TECHNICAL DOCUMENTATION CHANGE NOTICE

This Change Notice provides information affecting the KC750 Technical Manual - EK-KC750-TM-002.

o Page 3-2 Table 3-1 KC750 Option Modem Data

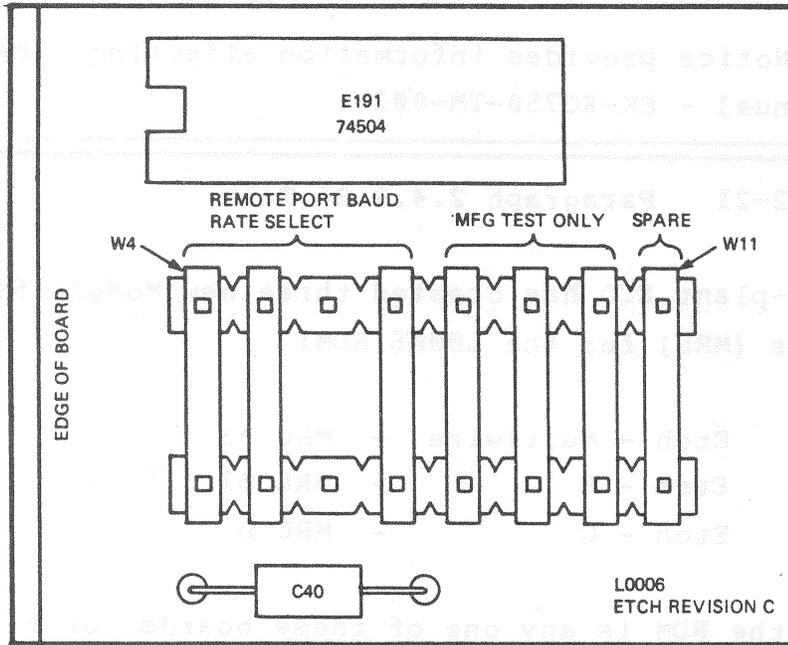
The FCC Registration Number for the DF02 DIGITAL modem is A0994Q-67693-DM-R and its Ringer Equivalence Number is 0.3A.

o Page 3-5 Figure 3-2 Location of Baud Rate Jumpers on the RDM

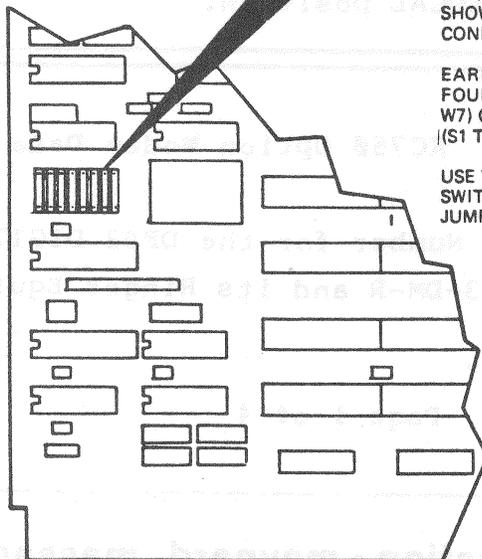
A note is added to the figure to indicate that only Revision C etch boards have the set of eight jumpers. Earlier boards have either a set of four jumpers or a four-switch pack.

ETCH REVISION C BOARDS HAVE THE EIGHT-JUMPER PACK (W4 THROUGH W11) AS ILLUSTRATED. THIS FIGURE SHOWS THE FACTORY-SET 300 BAUD CONFIGURATION.

EARLIER BOARDS HAVE EITHER A FOUR-JUMPER PACK (W4 THROUGH W7) OR A FOUR-SWITCH PACK (S1 THROUGH S4).

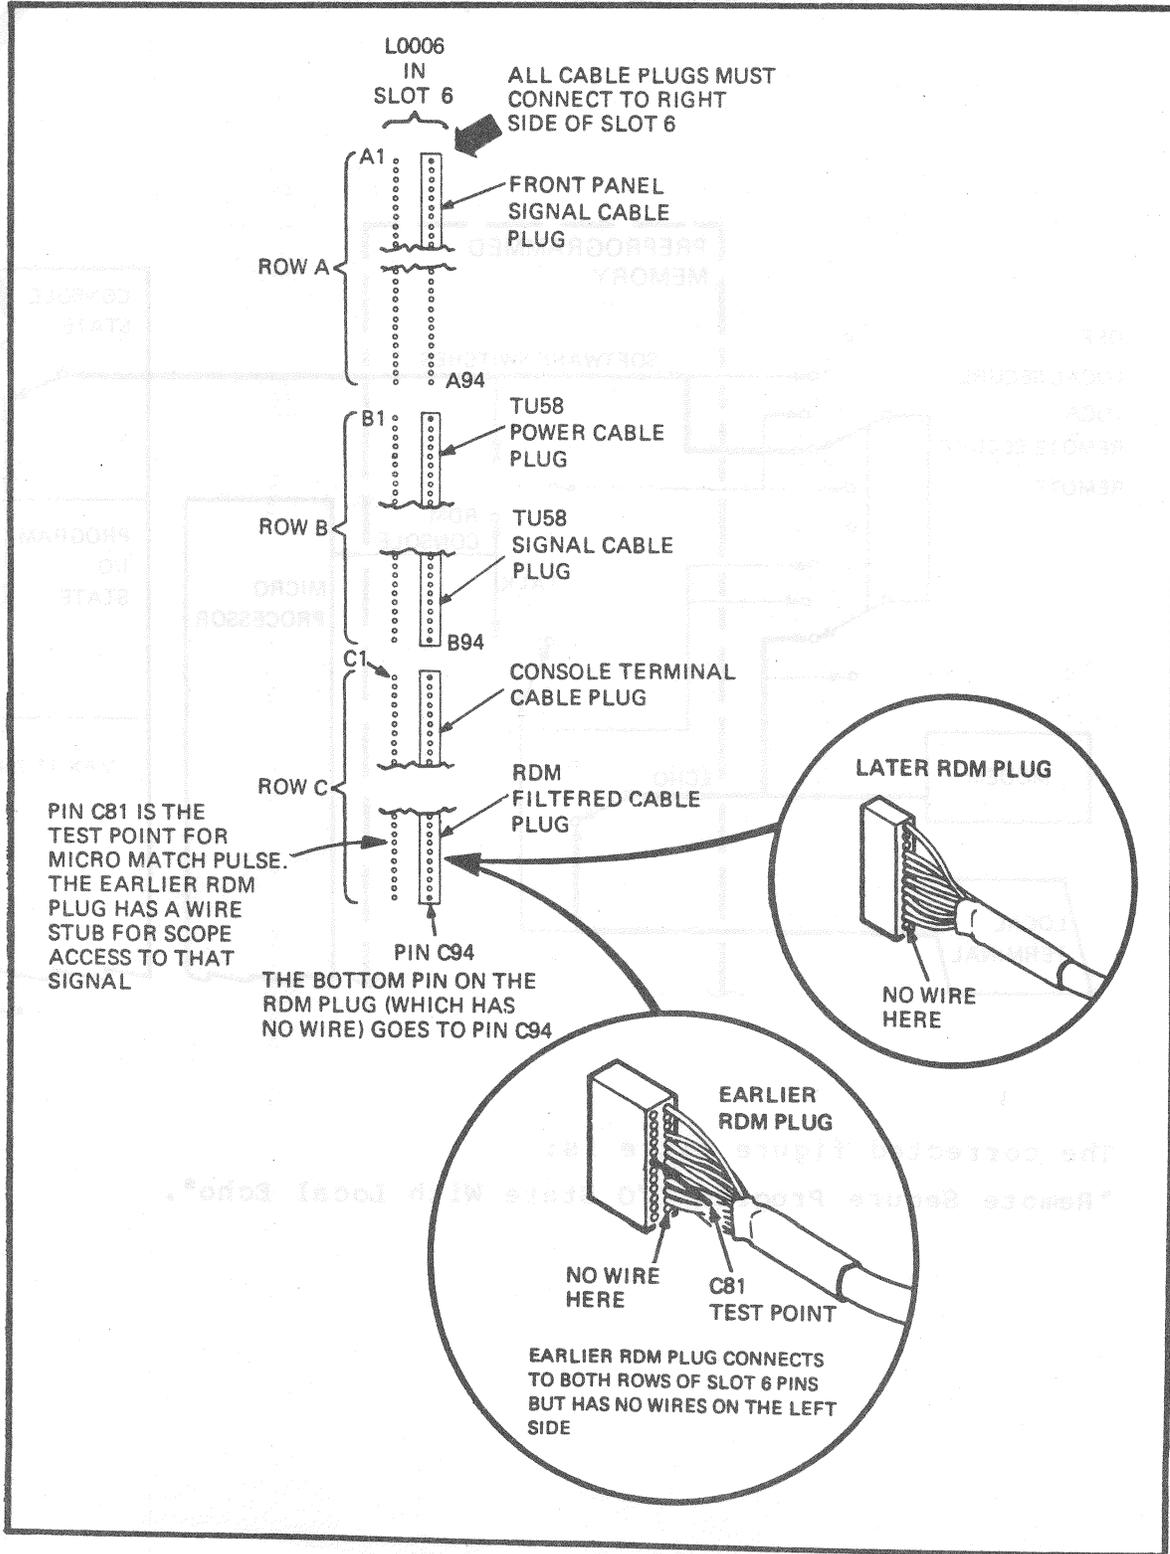
The figure is changed to show that the TU58 Power Cable plug must be connected to the pins on the right side of slot 6. Other changes show the two types of RDM plugs and how they are connected.

Figure 4-3 Remote Secure VAX Console State With Local Echo

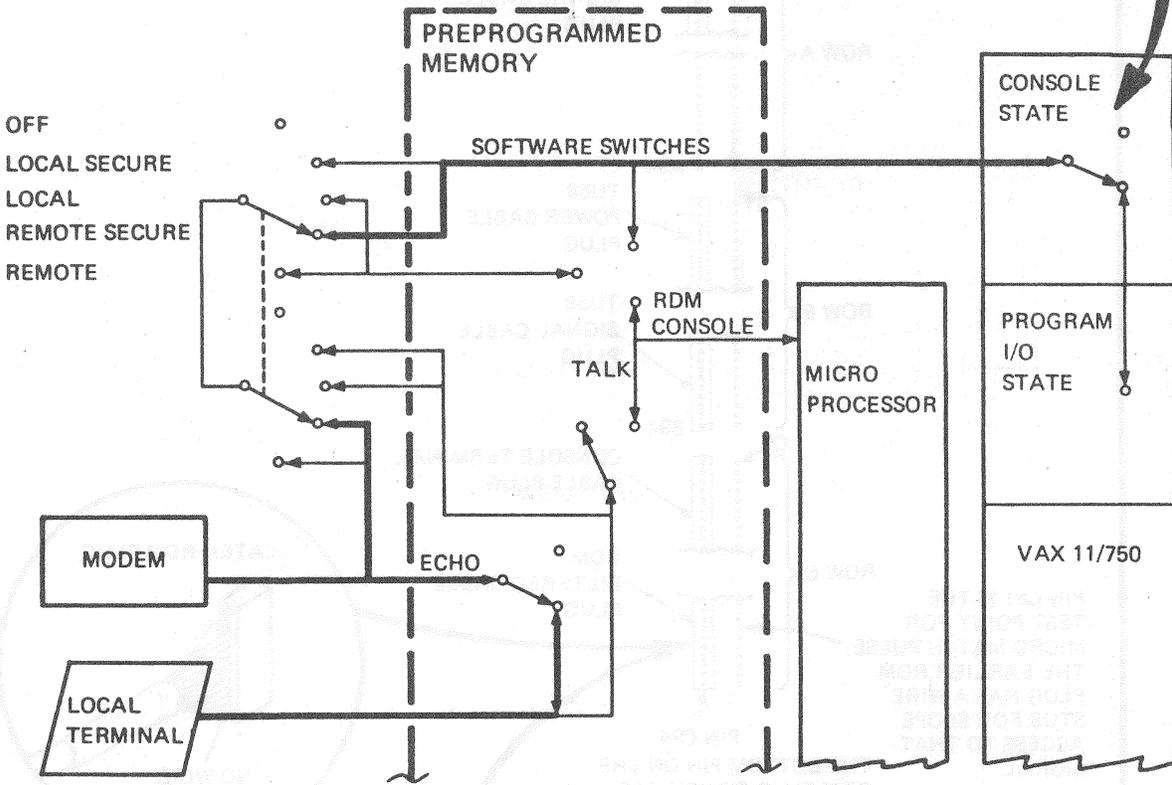
The figure is changed to show Program I/O State instead of Console State. Console State cannot be entered when the keyswitch is in the Remote Secure position.

The corrected figure title is:
"Remote Secure Program I/O State With Local Echo".
